SERVICE BULLETIN

NUMBER: SB 500-52-007, REV A
MODEL: ECLIPSE EA500
SUBJECT: LOWER CABIN DOOR STEP CABLE RESTRAINT

This Service Bulletin (SB) secures the lower cabin door step cable to the sector assembly.

Lower Cabin Door Assembly
Figure 1

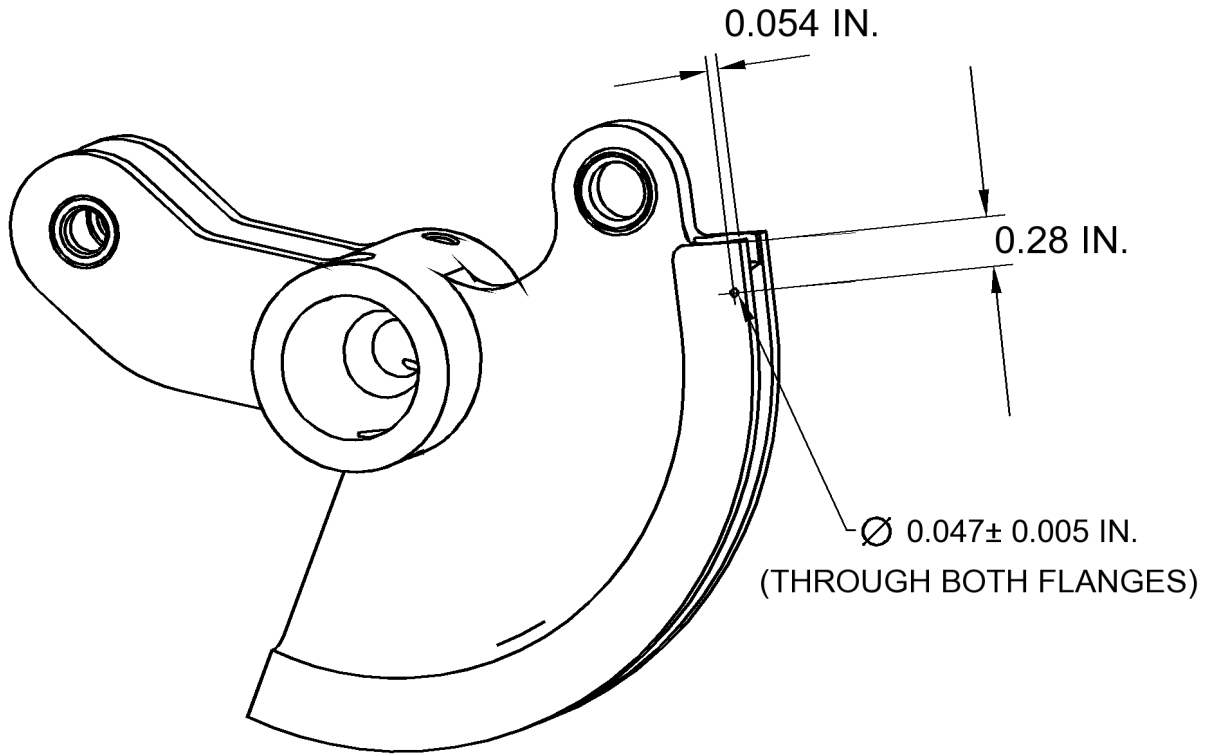
- (1) Make aircraft safe for maintenance. Refer to AMM 20-00-01.
- (2) Do Job Set-Up. Refer to SUBTASK AMM 52-60-10-001-921-001.
- (3) Remove upper step assembly (2, Figure 1) from lower door (1, Figure 1). Refer to step A of SUBTASK AMM 52-60-10-001-001-001.
- (4) Drill 0.047 (+/-0.005) diameter hole through both flanges of sector P/N 52-115033-1001. Refer to Figure 2.
- (5) Install upper step assembly. Refer to step A of SUBTASK AMM 52-60-10-041-411-001.
- (6) Insert MS20995C32 safety wire (3, Figure 3) through holes in sector P/N 52-115033-1001 (2, Figure 3) to secure step cable (1, Figure 3).
- (7) If all other maintenance is complete, return aircraft to service. Refer to AMM 20-00-02-051-921-001.
